CITY OF NEWTON, MASSACHUSETTS  
Department of Planning and Development  
Michael J. Kruse, Director

SUBJECT: **Petition #63-08 of 2101 WASHINGTON STREET LLC** for a SPECIAL PERMIT/SITE PLAN APPROVAL and EXTENSION OF A NON-CONFORMING STRUCTURE to redesign exterior parking and maneuvering areas, including a new perimeter driveway; increase to 105 the number of on-site parking spaces; waive various dimensional requirements relative to parking stalls; increase the number of identification signs; modify on-site lighting and landscaping; install an acoustical fence along the westerly boundary; reduce the maximum number of beds from 190 to 180; and, add a porte-cochere to the front of an existing nursing home facility at 2101 WASHINGTON STREET, Ward 4, NEWTON LOWER FALLS, on land known as Sec 42, Blk 9, Lot 17 containing approx 126,432 sf of land in a district zoned SINGLE RESIDENCE 2.

Re: **Zoning Review: Newton Health Care Ctr. – Skilled nursing home facility renovation; associated parking and site alterations.**

Figure 5. South west parking area

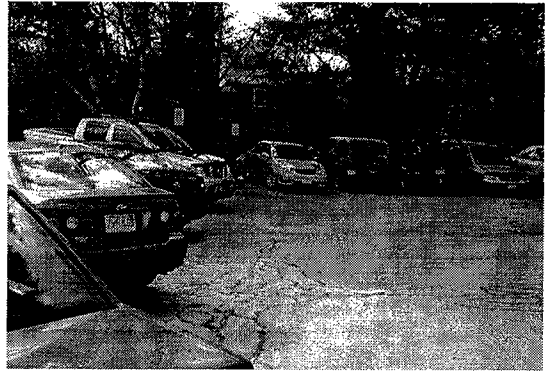
The use of the southwest parking area has been an ongoing concern of area residents. Under existing conditions, the loading area for the nursing facility and 14 parking spaces are located on the southwest side of the building in close proximity to the residential abutters on Belmore Park. In the proposed plan the number of parking spaces in this area is reduced to 6, though a trash compactor and a generator will remain.

It is unfortunate that these uses are located so close to residential abutters. The petitioner is not able to move these ancillary activities, but has suggested that the situation will be improved with the installation of a new, quieter emergency generator along the west side of the building. The petitioner engaged the services of a sound consultant, Cavanaugh Tocci Associates, to conduct environmental noise

Figure 7. Belmore Park

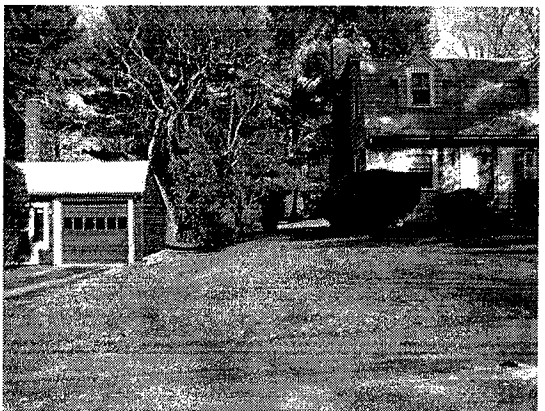
measurements at the facility. The acoustical consultant concluded that the “primary constant noise sources are traffic noise from Rt. 128 and, secondarily, traffic noise from Washington Street.” The noise levels during the daytime were measured at approximately 58 dB, which is high enough that most equipment, with the exception of the emergency generator, “blend into the overall ambient environment.”

2101 WASHINGTON STREET  
FIRE ACCESS PLAN

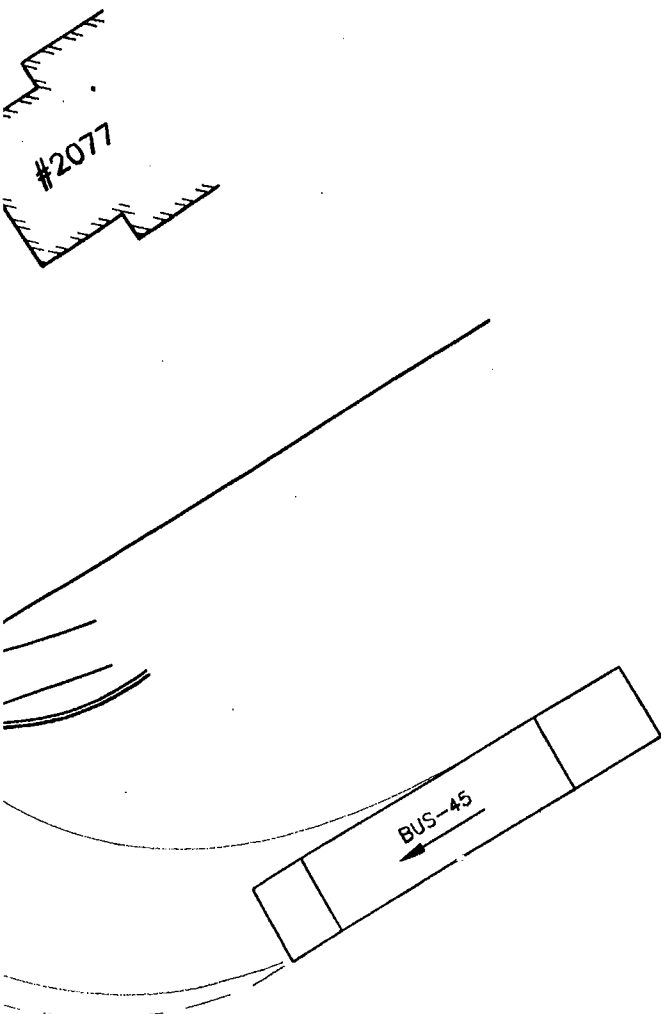
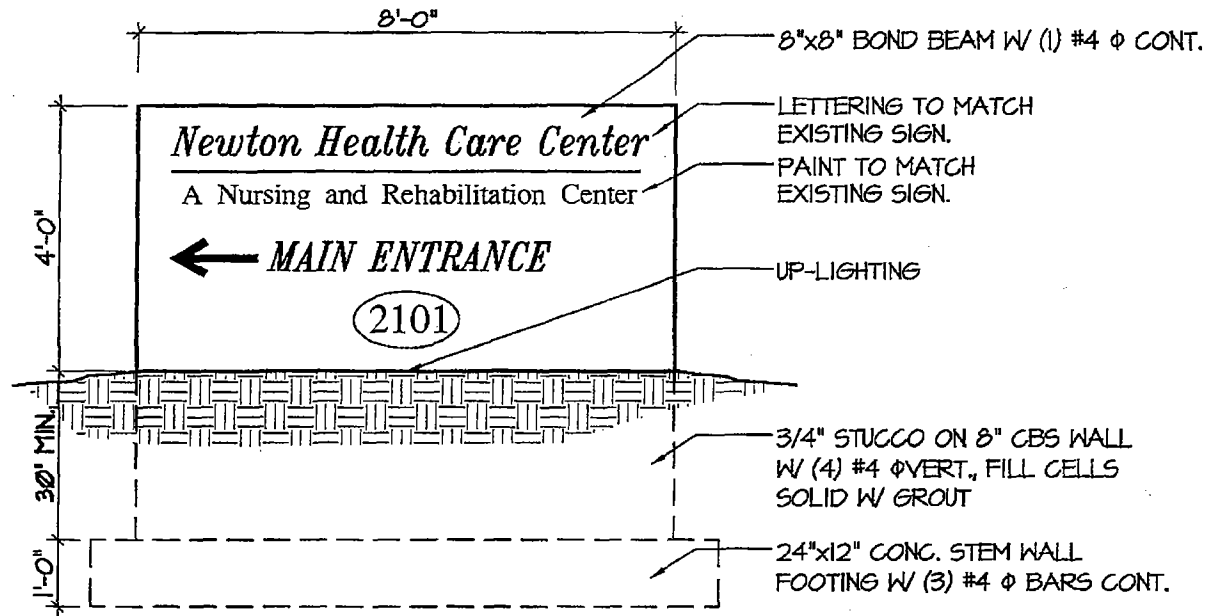
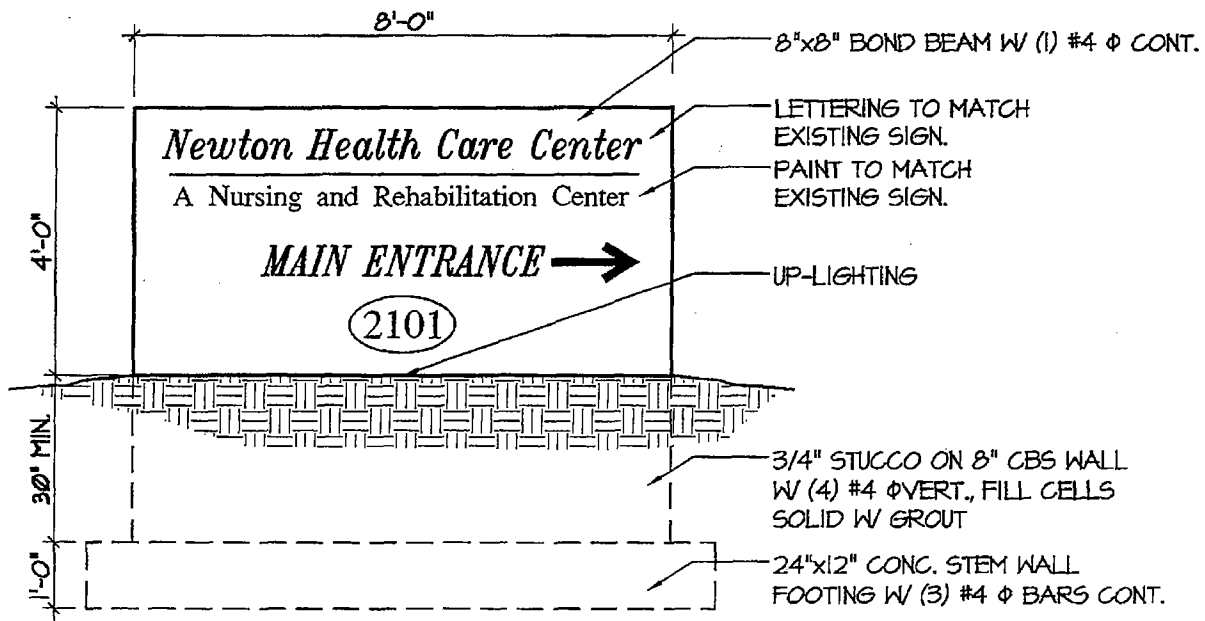
PLANS HAVE BEEN REVIEWED AND ACCEPTED AS  
NOTED

EXTERIOR  
SIGN #2

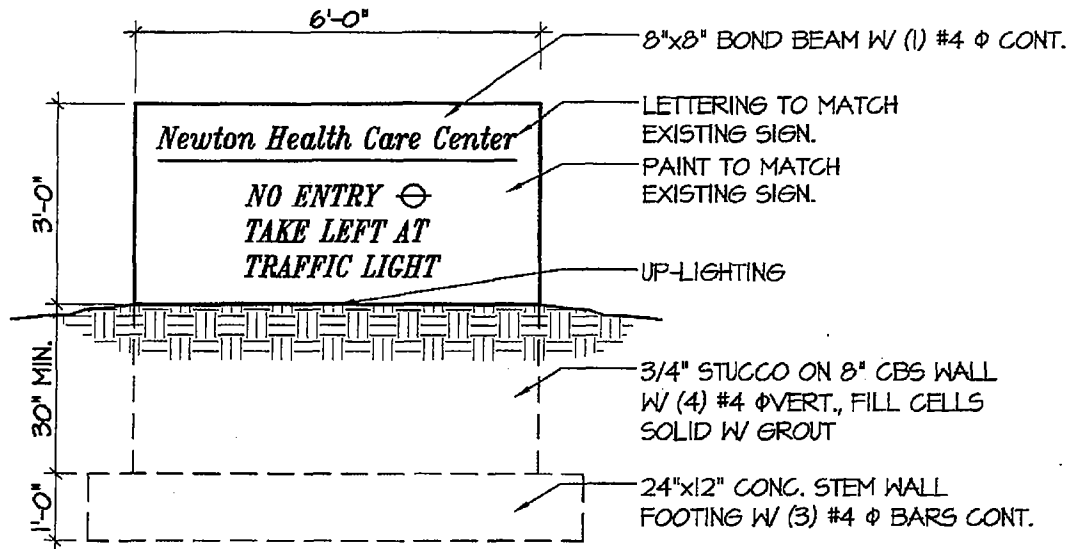
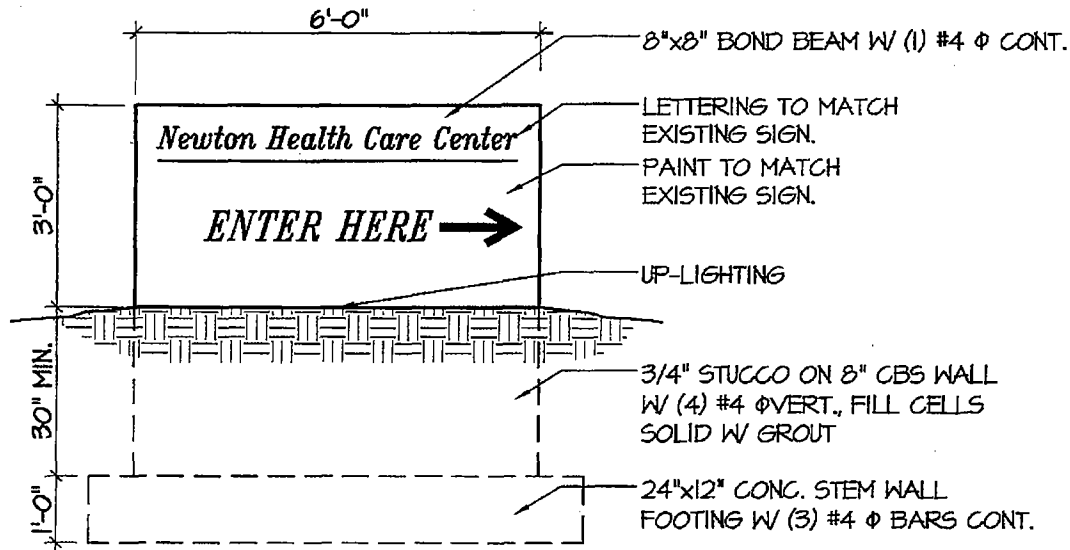
three signs at 32 sq. ft. Signs #2 and #3 are both smaller at 18 sq. ft. The Zoning Review Memorandum, dated August 30, 2007 (*SEE ATTACHMENT "A"*), notes that one sign is 32 square feet and signs #2 and #3 exceed the 20 square foot limit and require a waiver. However, the current plans show both signs to be 18 square feet and in compliance with the Zoning Regulations and do not require a waiver.

Uplighting is indicated for the three freestanding signs. The City's Light Ordinance, dated March 21, 2005, requires that light sources shall shine downward, with an exception for light sources, which are rated at a total that does not exceed 100 lumens. The petitioner must either demonstrate that the uplighting is less than 100 lumens or change the lighting to down lighting that meets the requirements of the light ordinance. The signs are painted, but the underlying material is not indicated and should be identified.
